Evaluation of Charles River Road Realignment Concepts on Pedestrians in Watertown Square

The Town of Watertown, working with VHB, is testing different concepts regarding Charles River Road with the goals of improving overall traffic safety and wayfinding, and of enhancing the pedestrian experience in Watertown Square. WalkBoston, funded through the EOPSS Pedestrian Safety Initiative, was asked to provide the Town with additional information on the effects of VHB's realignment concepts on people walking through the Square.

Appendix A. Watertown Square Traffic Signal Wait/Walk Times and Observations

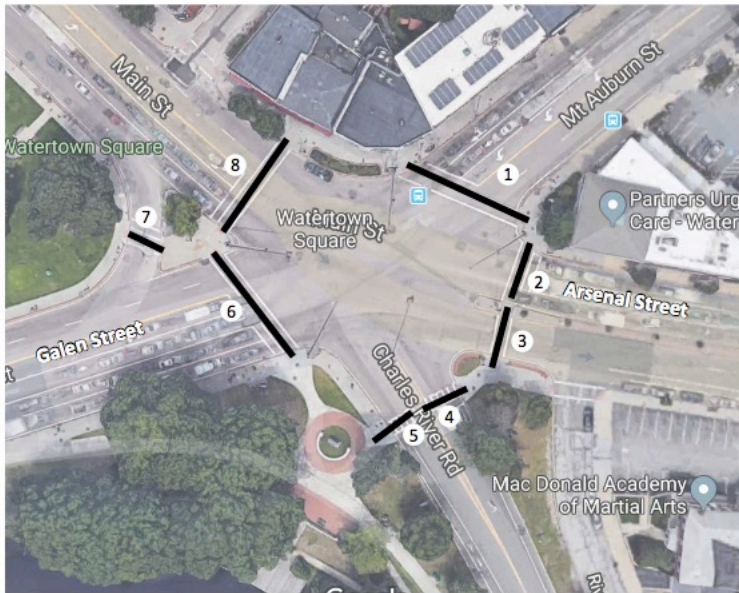
- The 3/4/5 signals come on at the same time, yet there isn't enough time to make the final connection from Arsenal Street across Charles River Road to the park/riverfront. The wait is another ~1:40 to get across the last lane, so people do not wait.

- The WALK signal for 7 comes on before 8, which is desirable if crossing from the delta to the waterfront park, but not the other way around.
- When drivers going straight on Mt Auburn Street get a green light, traffic from the slip lane has a red light, but walkers at 7 are held. Right turns on red are allowed from the slip lane after drivers stop. Depending on the number of turning movements, consider giving walkers a WALK sign during the vehicular red and prohibiting right turns on red. As it is, people do not wait and cross to the triangle.

- Additional clearance time is needed before the WALK because people driving continue to enter the intersection even after red arrow, adding potential conflicts with walkers.
